PROOF OF PUBLIC PARTICIPATION

Proposed Rezoning and Subdivision to create single residential erven on Erf 1486,
Vermont, Overstrand Municipality

May 2026

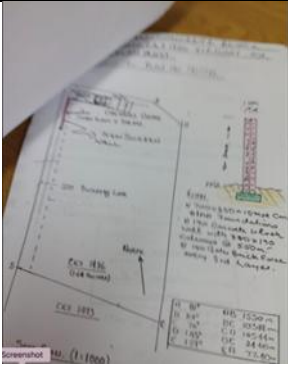
With the alien clearance extent, the wetland on RE/572 has enlarged up to the fence with the R 43 and erf 1486. The red area in photo 3 below depicts the wetland shape as per recent observation. The building on erf 1486 in picture was elevated when originally constructed in order to be raised out of the wetland, infilling on the site took place over the years to allow for drier disturbed areas and the alien vegetation has increased resulting in much “drier” and less wetland conditions in up to the alien clearance started on RE/572. However now with the alien vegetation removal of approx. 20 ha and climate change predictions the wetlands will	wetland. <i>The Delta Ecology (2023) report’s scope does not include assessing the potential impact of climate change, adjacent changes in land use, or any other potential catchment transformation that may occur in the future; and how (if applicable) the boundary of the wetland will change as a result of such changes. The report has been updated to include this exclusion in the Limitation Section 1.2. of the report (Delta Ecology, 2023).”</i> Freshwater Specialist response: “The comment is acknowledged, and changes in the wetland boundary should be monitored. The recommendation to monitor the potential expansion in the onsite wetland boundary over time will be included in the Wetland Management Plan. <i>It is recommended that the HoA ensures that no private landowners’ resort to interventions to drain or infill the remnant UVBW. The designs for houses on the residential Erven should take cognisance of the wetland’s sensitivity and this should be enforced by the HoA through the Wetland Management Plan. The Delta Ecology (2023) report has been updated as necessary to include this mitigation measure.”</i> Freshwater Specialist response: A SWMP is recommended. However, it is the specialist’s opinion that the proposed development will not have a substantial impact on the hydrology or interflow dynamics of the onsite wetland and downstream system given the implementation of mitigation measures. <i>The Delta Ecology (2023) report’s scope does not include assessing the potential impact of climate change, adjacent changes in land use, or any other potential catchment transformation that may occur in the future; and how the onsite wetland’s surface and subsurface water flow may change as a result thereof. The report has</i>

increase and it's highly likely that Erf 1486 will be more inundated with water. UVA Prop therefore don't support the development in its current format until the required additional studies are conducted, avoidance of the CE vegetation and seasonal wetlands entirely should be the preferred mitigating measure before offsets are considered, due to the flood risks. We recommend that an alternative be assessed where total avoidance is applied. Further note that UVA Prop can't be held liable for any additional water flow towards the east due to the conservation efforts that can result in flooding or water inundation of the proposed development on erf 1486 Vermont. The owners of RE/572 and PHS Consulting should be registered as I&AP's please. We reserve the right to provide further comments.	<i>been updated to include this exclusion in the Limitation Section 1.2. of the report (Delta Ecology, 2023). The scope of the recent studies (specifically EnviroSwift, 2018 and Delta Ecology, 2023), included assessment of the present state of the onsite wetland determined to be At-Risk of the proposed development, and subsequently the potential impacts of the proposed development on this wetland. There may potentially be a slight increase of flow due to the hardened surfaces as a result of the housing development. This is seen to be of "Low "significance" to the onsite wetland, given the implementation of mitigation measures such as implementing rainwater harvesting schemes that may reduce runoff intensity, and mitigate the potential impact of catchment hardening.</i> <i>To ensure the implementation of recommendations in the Aquatic Impact Assessment Report (Delta Ecology, 2023), the report has been updated to specify that an Aquatic Ecologist must be consulted during the design of the onsite Residential Dwellings and Town Housing unit, and an Environmental Control Officer (ECO) should be appointed during the Construction of the Town Housing development in the south.</i> Freshwater specialist response: <i>"The scope of the recent studies (specifically EnviroSwift, 2018 and Delta Ecology, 2023), included assessment of the present delineation and state of the onsite wetland determined to be At-Risk of the proposed development, and subsequently the potential impacts of the proposed development on this wetland.</i> <i>The Delta Ecology (2023) report's scope does not include assessing the potential impact of climate change, adjacent changes in land use, or any other potential catchment transformation that may occur in the future; and how the onsite wetland's surface and subsurface water flow may change as a result thereof. The report has been updated to include this exclusion in the Limitation Section 1.2. of the report (Delta Ecology, 2023)."</i>

Figure 1. Revised site development plan (Revision 24) presented to CapeNature following our comments submitted on 28 October 2025 wherein the residential erven avoid the delineated wetland and to which CapeNature does not object.

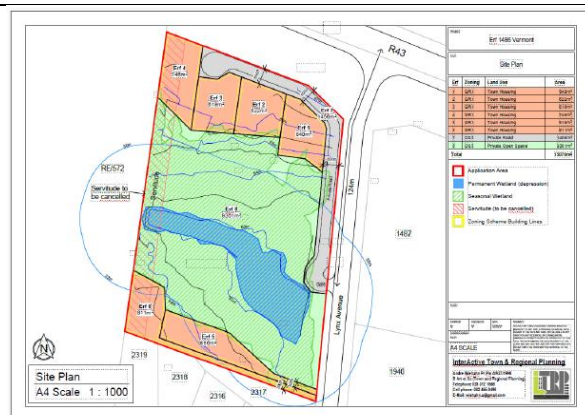
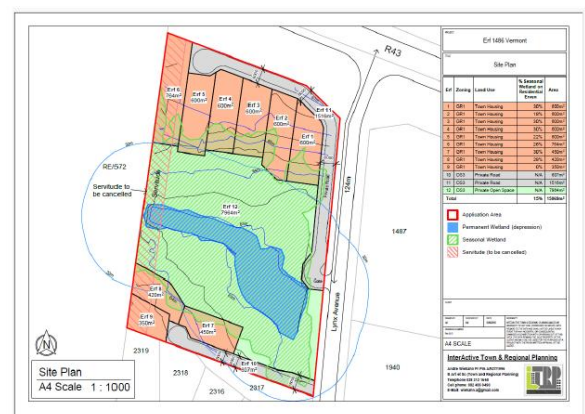
3.2. It is noted that CapeNature still does not support the preferred alternative, as the wetlands are not entirely avoided. Despite the Breede-Olifants Catchment Management Agency not raising any concerns regarding the wetland offset, an additional motivation must be included in the Final BAR to explain why the layout cannot be amended to fully avoid the seasonal wetland, taking the mitigation hierarchy into consideration. Final comment must be obtained from CapeNature regarding the above and must be included in the Final BAR. 3.3. The Maintenance Management Plan (MMP) indicates that Activity 13 of Listing Notice 1 is applicable to the maintenance activities. This must be corrected, as Activity 19 of Listing Notice 1 is the applicable activity. Furthermore, the MMP still refer to swales, although it was indicated that these have been removed from the development. Please ensure that the Final BAR, EMPr, and MMP reflect the correct information regarding the proposed development. 3.4. Insufficient proof was included in the Revised DBAR that a water use license application in terms of the National Water Act, 1998 (Act No. 36 of 1998) was submitted to the Department of Water and Sanitation ("DWS"). Proof that DWS have received your submission must be included in the Final BAR. 3.5. Omission of any required information in terms of Appendices 1 and 4 of the EIA Regulations 2014, with regards to the final submission of the BAR and EMPr, respectively to the Department, may result in the application for Environmental Authorisation being refused. 3.6. Be advised that an electronically signed and dated applicant declaration is required to be submitted with the final BAR to this Department for decision-making. It is important to note that by signing this declaration, the applicant is confirming that they are aware and have taken cognisance of the contents of the report submitted for decision-making. Furthermore, through signing this declaration, the applicant is making a commitment that they are both willing and able to implement the necessary mitigation, management and monitoring measures recommended within the report with respect to this application. 3.7. In addition to the above, please ensure that the electronically signed and dated Environmental Assessment Practitioner ("EAP") declaration is also submitted with the final BAR for decision-making. 4. Kindly quote the abovementioned reference number in any future	refer to Cape Nature's comments below. The MMP has been updated. Correspondence has been received from BOCMA, refer to Appendix L.

Concerns were also raised that there was insufficient investigation regarding mechanisms whereby the wetland offset can be secured. We recommend that supplementary information is provided in this regard with the final submission to DEA&DP and that a copy is provided to CapeNature for record-keeping

Figure 0-1: At risk wetland.

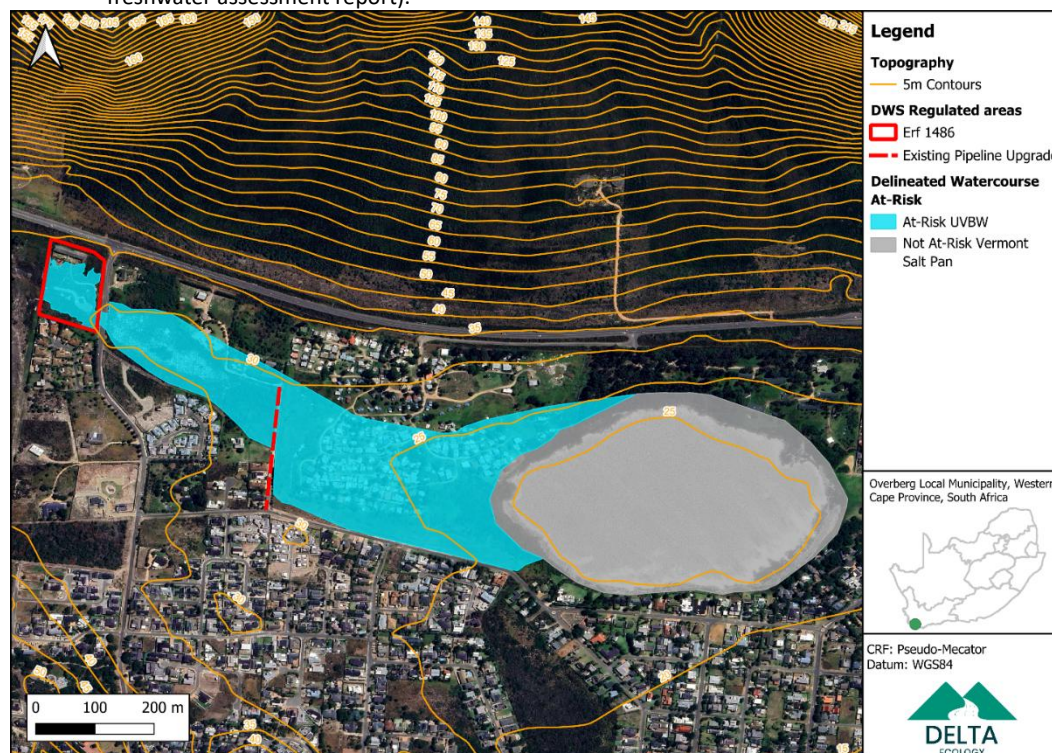
3. Upstream wetland areas that are unaffected by the proposed development are not required to be included within the scope of work. However, the broader system context was considered through reference to the downslope linkage with the Vermont Salt Pan (see Figure 5-15 from the freshwater assessment report).

The Aquatic Impact Assessment Report also considered the broader system in its evaluation when considering potential impacts, please refer to the Delta Report Version 4. Furthermore, as the wetland is connected to the broader downslope system, it is reasonable to assume that any rehabilitation undertaken on the site in question will contribute to improving the functioning of the overall system. However, this potential benefit was not included in the offset calculation in

Figure 1. Revised site development plan (Revision 24) presented to CapeNature following our comments submitted on 28 October 2025 wherein the residential erven avoid the delineated wetland and to which CapeNature does not object.

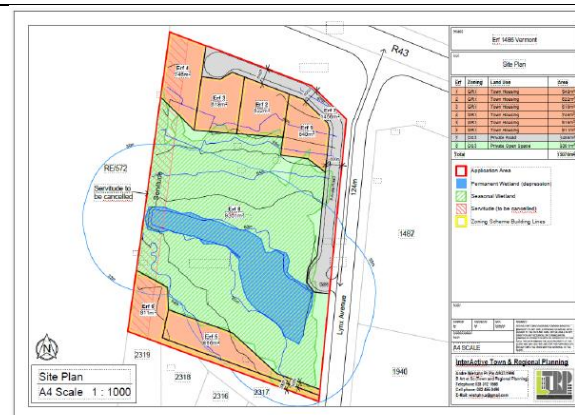
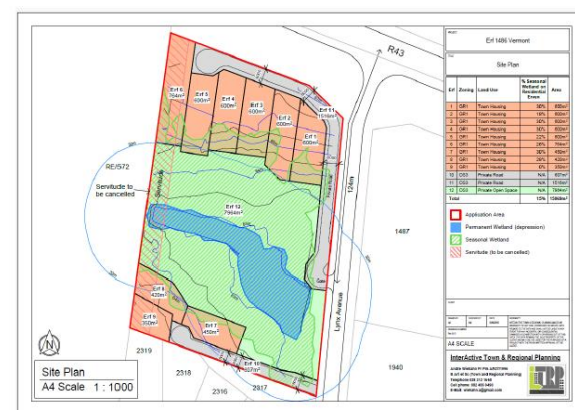
Rhett Smart	Cape Nature			rsmart@capenature.co.za	Letter dated 06 November 2025 Amended Site Development Layout for the Proposed Residential Development on Erf 1486, Vermont, Hermanus (DEA&DP ref no 16/3/3/1/E2/40/1046/25) CapeNature would like to thank you for the opportunity to comment on the application and would like to make the following comments. The primary outstanding concern regarding the application after four rounds of public participation is the encroachment of the residential erven into the delineated wetland as indicated in our most recent comments dated 28 October 2025. A motivation was provided that there are restrictions regarding the minimum size of erven within the suburb of Vermont. Subsequently the applicant has provided a revised layout plan whereby the residential erven avoid the delineated wetland. There are very small linear encroachments which are unavoidable and for all intents and purposes and considering the motivation provided in the wetland delineation review regarding the wetland delineation, the current layout avoids the residential erven encroaching on the wetland. CapeNature is therefore satisfied that our concern has been addressed. For record purposes, the current layout which we do not object to is indicated as Revision 24 and dated 25 September 2025 as indicated in Figure 1 below, whereas the layout presented in the most recent round of public participation (Final Basic Assessment Report) where there was encroachment into the wetland is indicated as Revision 20D and also dated 25 September 2025 and indicated as Figure 2 below.

Figure 1. Revised site development plan (Revision 24) presented to CapeNature following our comments submitted on 28 October 2025 wherein the residential erven avoid the delineated wetland and to which CapeNature does not object.

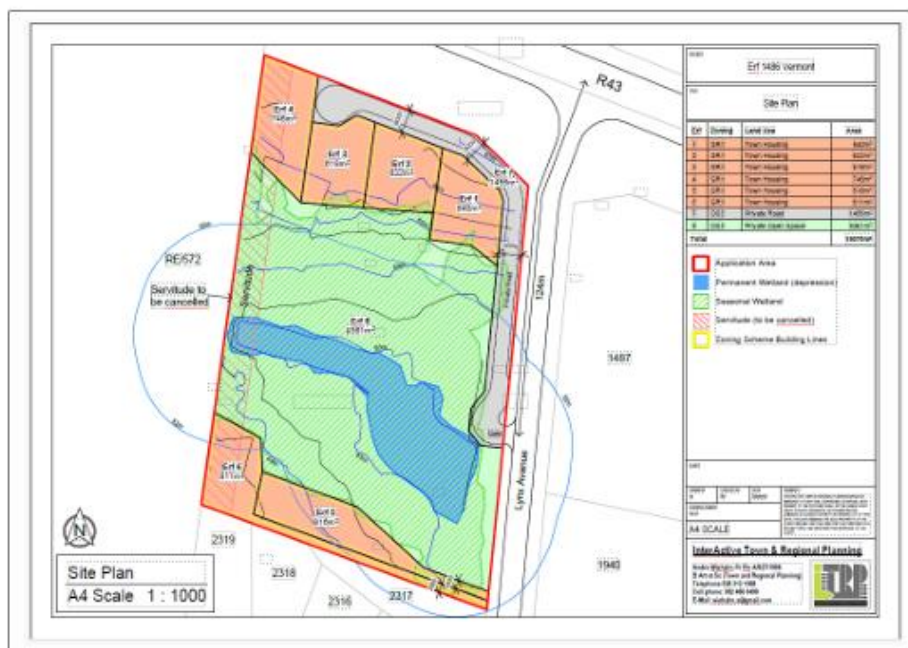
For record purposes, the current layout which we do not object to is indicated as Revision 24 and dated 25 September 2025 as indicated in Figure 1 below, whereas the layout presented in the most recent round of public participation (Final Basic Assessment Report) where there was encroachment into the wetland is indicated as Revision 20D and also dated 25 September 2025 and indicated as Figure 2 below.
